Selection of the default LDM patterns in Femto ABS (15.4.10.2)

IEEE C802.16m-09/2415

To be discussed and adopted by TGm for the P802.16m/D2

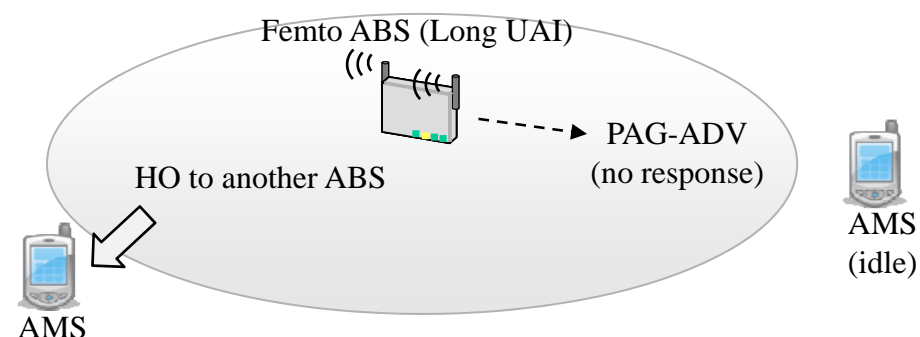
- Selection of the default LDM pattern is a trade-off issue:
 - Short UAI
 - Pros : Shorter latency of data transmission (sleep AMS) or network re-entry (idle AMS).
 - Cons: Smaller effect of interference mitigation.
 - Long UAI
 - Pros : Lager effect of interference mitigation.
 - Cons: Longer latency of data transmission (sleep AMS) or network re-entry (idle AMS).
- Based on the existence/status of AMS, the femto ABS can select suitable default LDM pattern.
 - AMS in sleep mode is connected or not.
 - Location update from idle mode AMS is detected or not.
 - CSG Femto ABS may send PAG-ADV(action code=0b01) for CSG AMS detection.

Case a) Sleep or idle AMS is in the coverage

Case b) No AMS is in the coverage

There may be one or more default LDM patterns in a femto ABS deployment. **The femto ABS may select the default LDM pattern with longer unavailable interval when no AMS exists in its service range.** The Default LDM pattern(s) parameters can be pre-provisioned or unicasted to the AMS during initial network entry with the femto ABS in the AAI_REG-RSP message.
